# HISTORIC CONSERVATION BOARD AGENDA

Monday, September 11, 2017 at 3:00 pm

## APPLICATION FOR CERTIFICATE OF APPROPRIATENESS HISTORIC CONSERVATION BOARD PUBLIC HEARING STAFF REPORT

APPLICATION #: COA2017053  
APPLICANT: Drawing Department  
OWNER: 9487 Dry Fork Rd LLC  
ADDRESS: **1429 Walnut Street**  
PARCELS: 080-0001-0082  
ZONING: CN-P  
OVERLAYS: Over-the-Rhine Historic District  
COMMUNITY: Over-the-Rhine  
REPORT DATE: August 31, 2017  
HEARING DATE: September 11, 2017  
STAFF REVIEW: Beth Johnson Urban Conservator

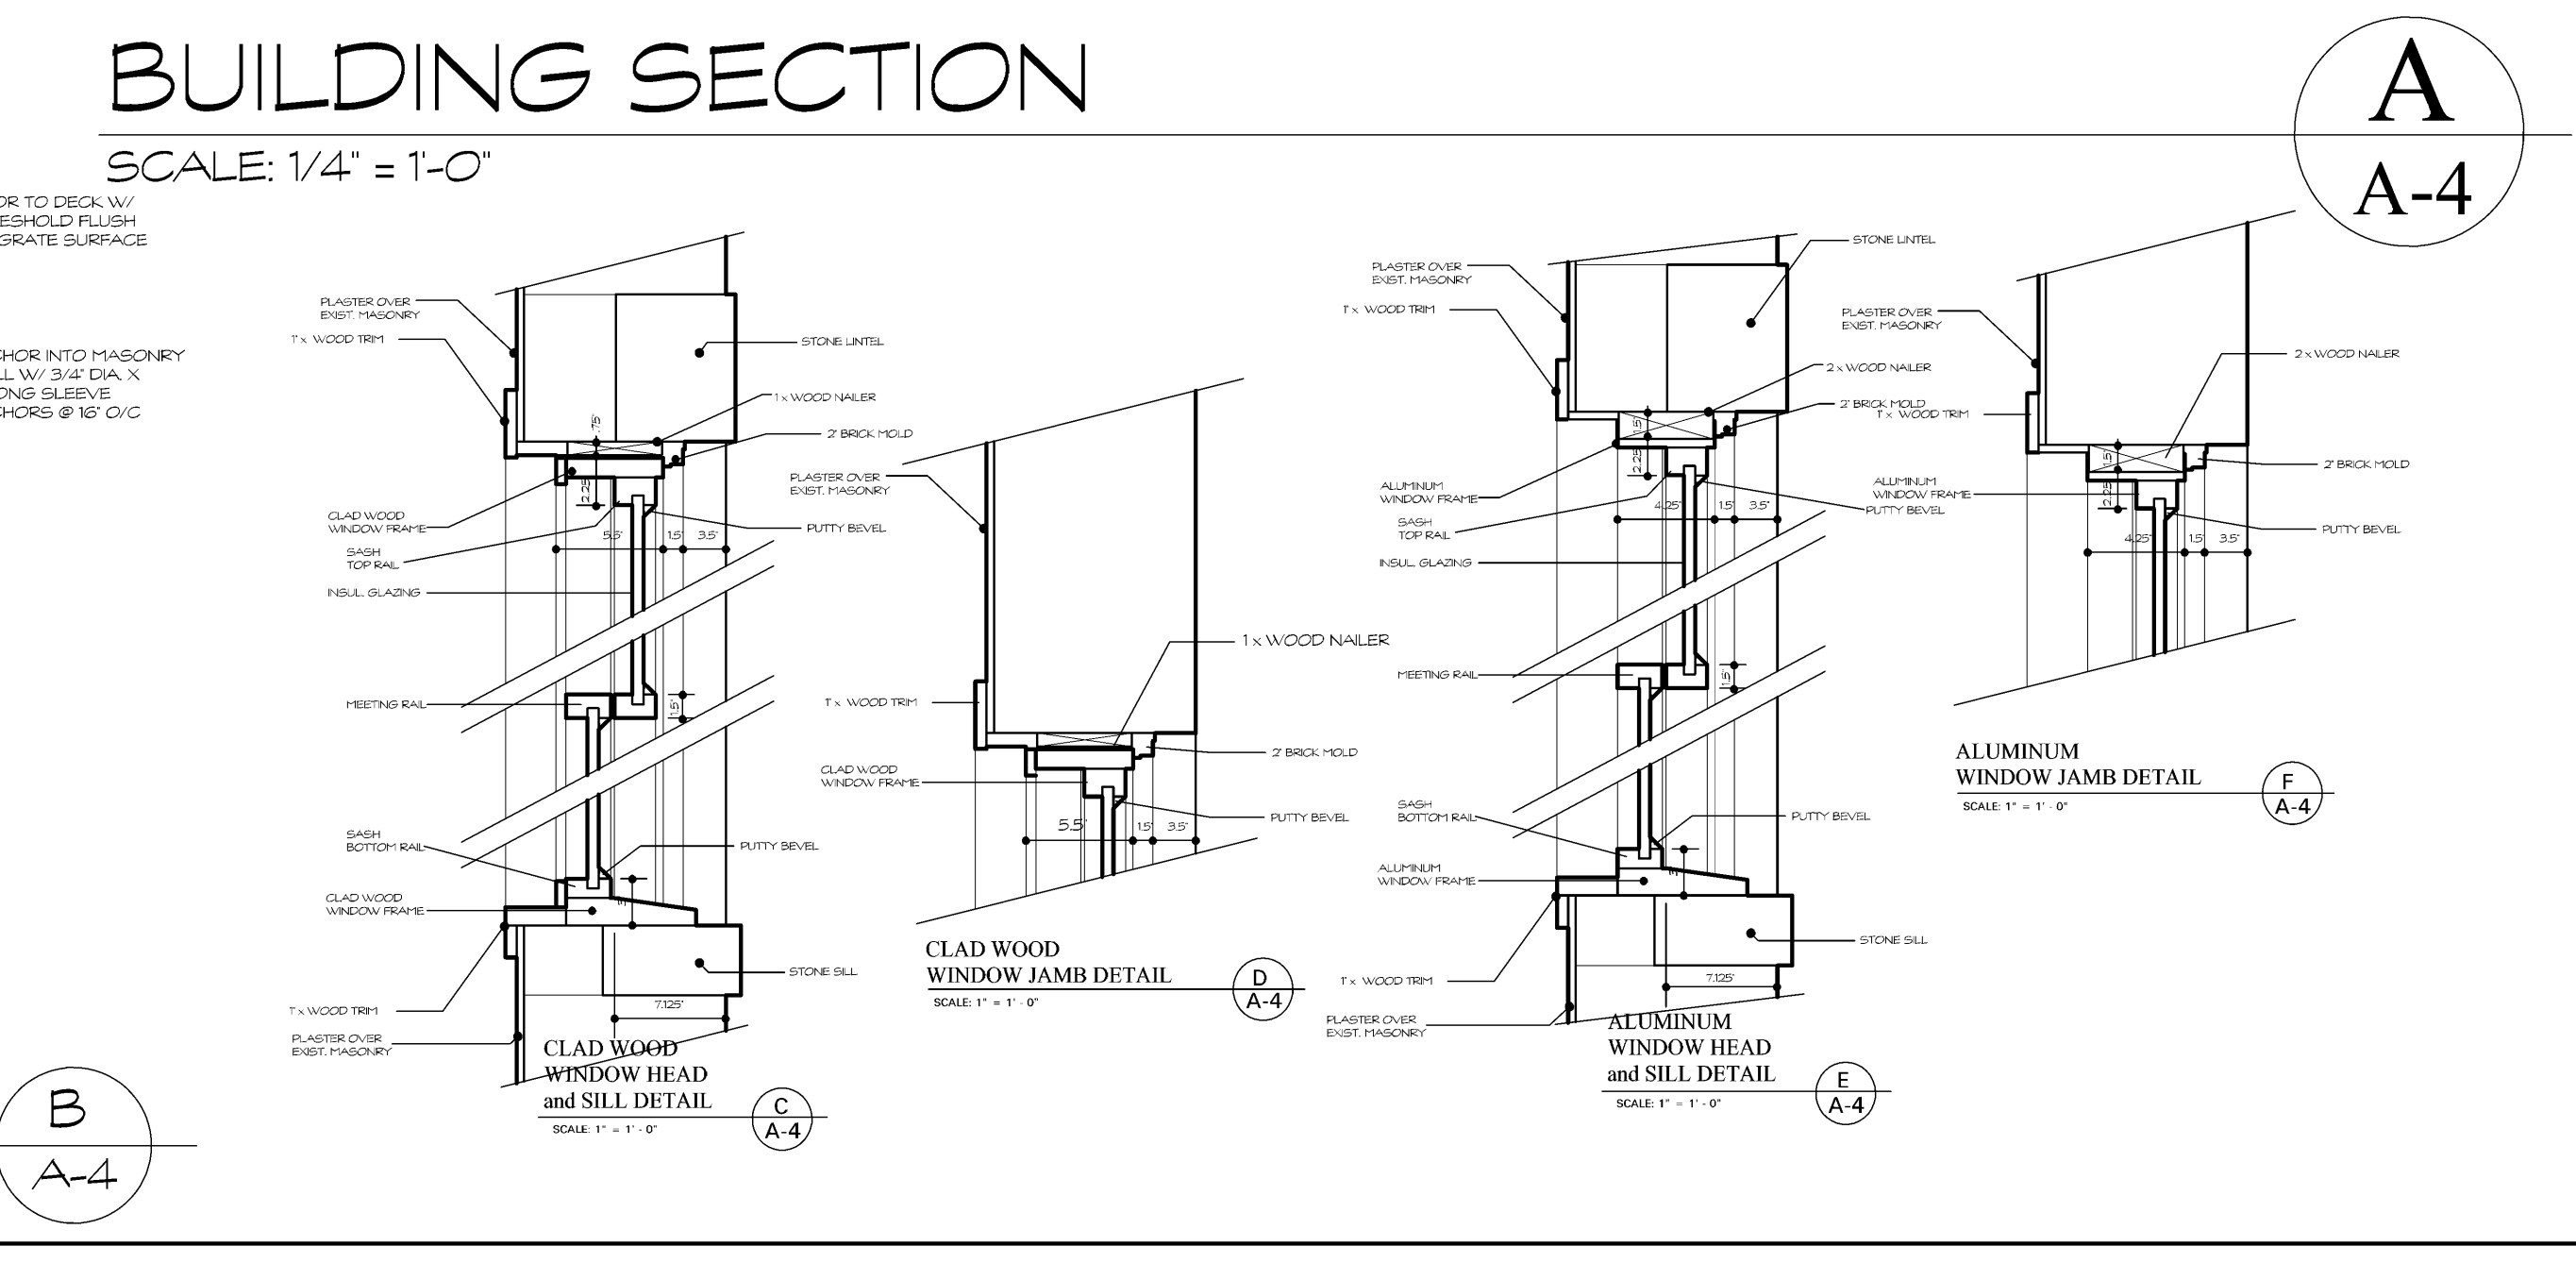
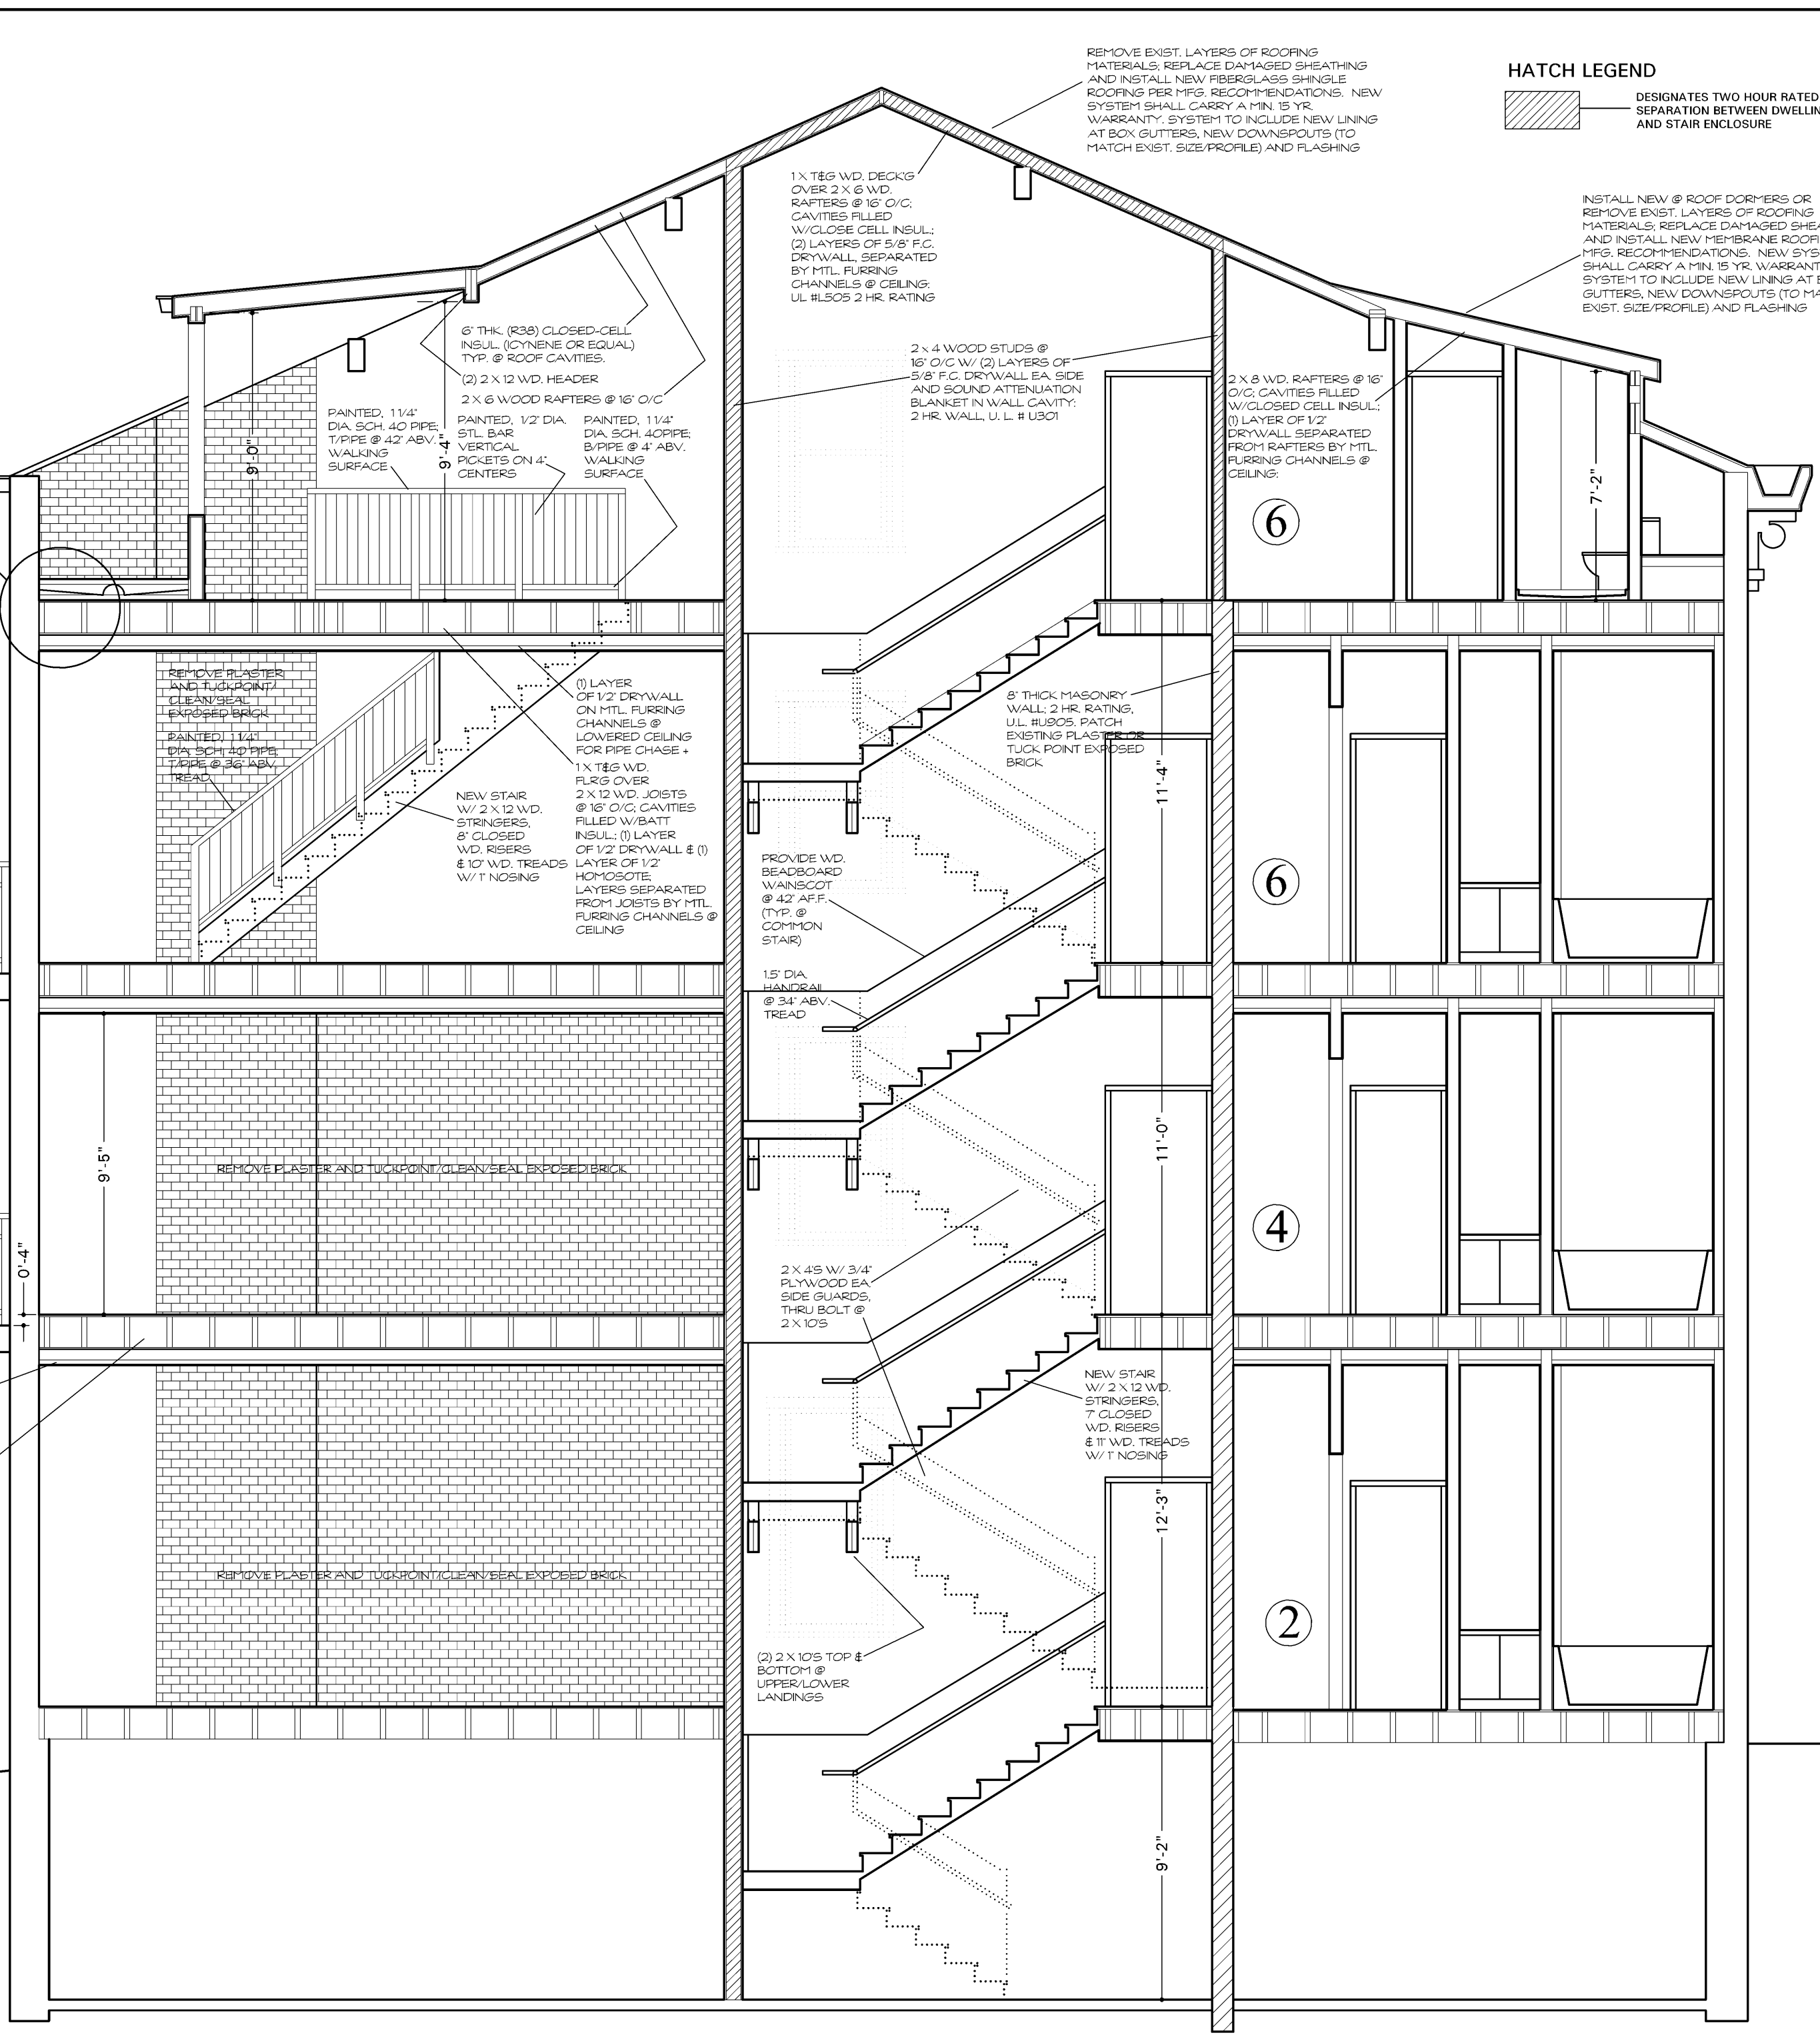
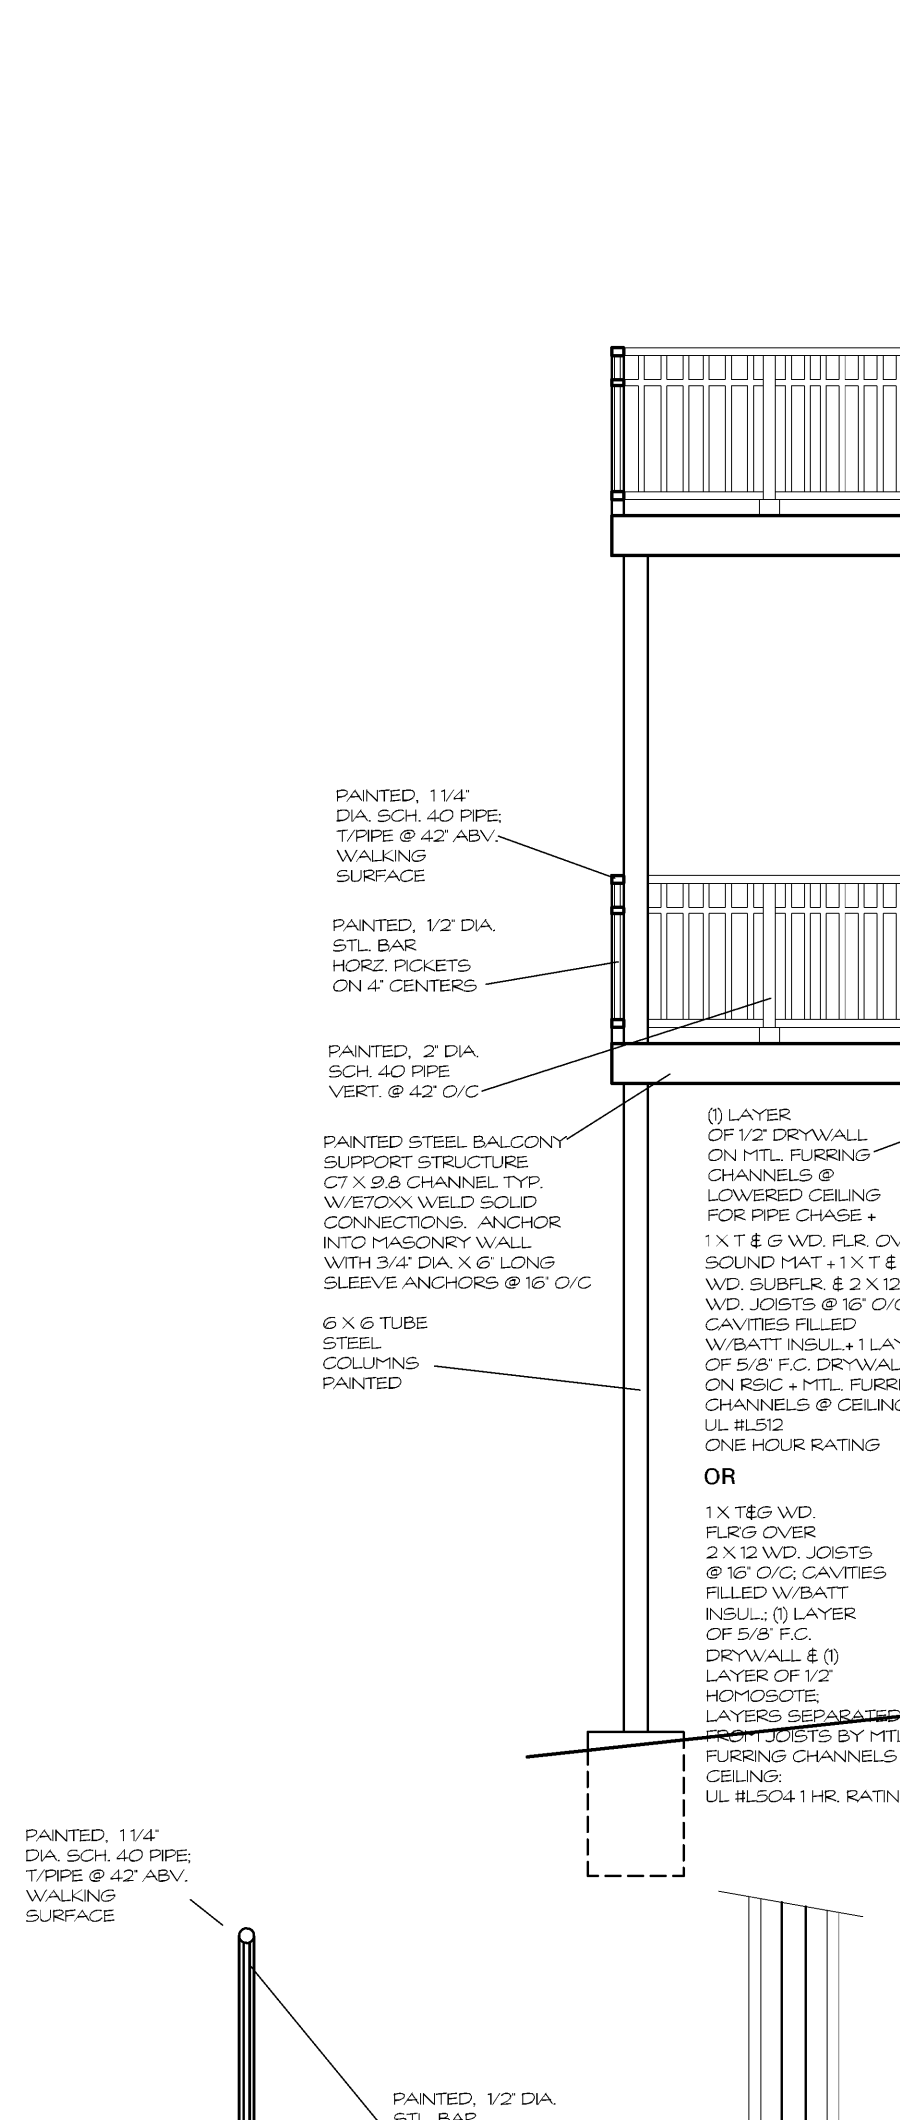
*We have often seen and permitted dormers of the rear of buildings in order to increase the height in the attic to provide for living space. While this changes the roof line, these changes are not visible from the primary street or are inconspicuously placed. Staff does not feel this is the case with the front dormer. Staff is supportive of the rear dormer as it won't be visible from Clifton and it isn't on the primary façade. This dormer will be visible from both Lang Street and at the intersection of Land and McMicken, but it will not detract from the architecture.*

*Staff is sympathetic to the stated economics issues of the project; however staff can not recommend that this portion of the project meets the Over-the-Rhine Historic Conservation Guidelines and does not feel that enough evidence has been submitted to prove an economic hardship. The applicants have submitted written testimony regarding the feasibility; however no number comparisons or floor plan studies were submitted for staff to review the economic viability of the project. For example, why can't the project support 2- 2 story units rather than just 1 and why can't the study be in the front of the*

*building and the bedroom in the rear. Studies are often smaller rooms. A minimum bathroom size is 6 ft by 6 ft and this could potentially be at the corner of the rear room and that would still provide a sizeable bedroom at over 10.5x10.5. The removal of the bathroom from the front would provide a still sizeable study.*

*Another option would be to retain the density at 7 units it to make the entire 4<sup>th</sup> floor one unit and keep the same floor plans on floors 1-3. This would allow for the elimination of hallways and the need for additional stairwell which would add additional square footage.*

**A.) TABLE** a Certificate of Appropriateness for 203-205 E Clifton Ave per plans submitted by Wichman Gunther Architects dates 6/15/2017 in order for the applicants to either remove the dormer or provide more substantial evidence of an economic hardship.
